**Case #:** PB 2013-15  
**Date:** September 12, 2013  
**Recommendation:** Conditional Approval

**PLANNING STAFF REPORT**

**Site:** 2-8 Broadway

Legal Notice: Applicant and Owner, Lolastar, LLC, seek a Special Permit with Site Plan Review under SZO §6.5.D.1 & 7.13.E to establish 11 residential units and under SZO §6.5.D.2 to establish by-right uses §7.13.B, and 7.13.C small and/or medium retail. The applicant seeks approval under SZO §9.17.2.A for reduced parking requirements, and §6.5.G.18 for the reduced lot area and §6.5.D.5 to alter facades and signage. Article 13 Inclusionary Housing will apply. TOD 55. Ward 1.

*East Broadway Streetscape Improvements in front of 2-8 Broadway.*

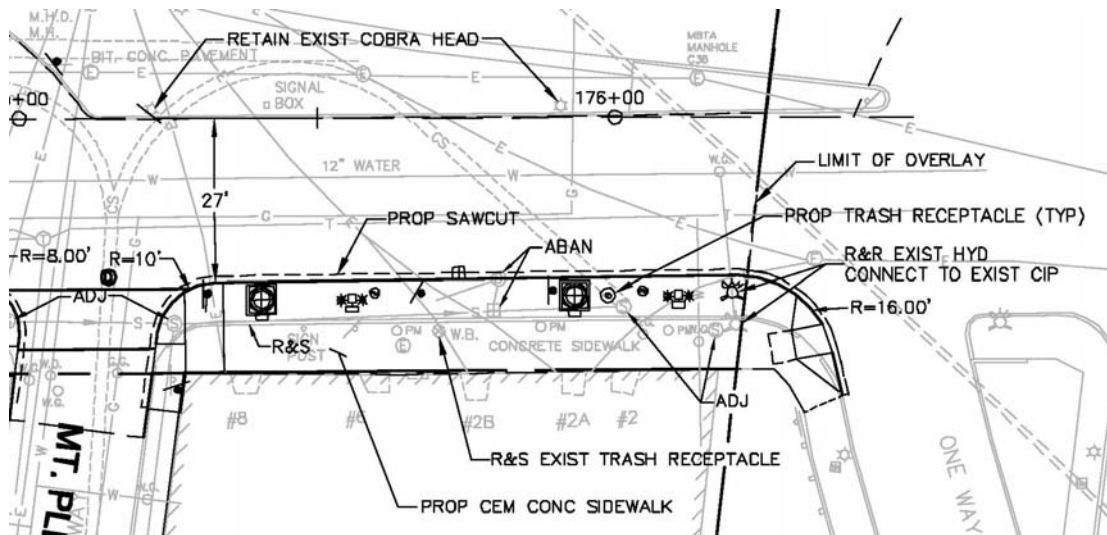
The project is ideally located near public transportation which includes Sullivan Square (orange line) and 12 bus lines. In addition, the East Broadway Streetscape improvements will increase pedestrian and cyclist accessibility. The East Broadway streetscape will widen the

sidewalk, add 2 new street trees in front of the property, and narrow the width of Broadway. The applicant has shown a bike corral ~~in a parking space~~ in front of the property as part of the streetscape sidewalk expansion, and this will be a condition of approval. The bike parking has been reallocated in the rear of the building. Three spaces have been moved inside. To maximize indoor bike parking, a condition of this report is that the Applicant will use a rack system to provide for bicycle parking for 6 spaces inside.
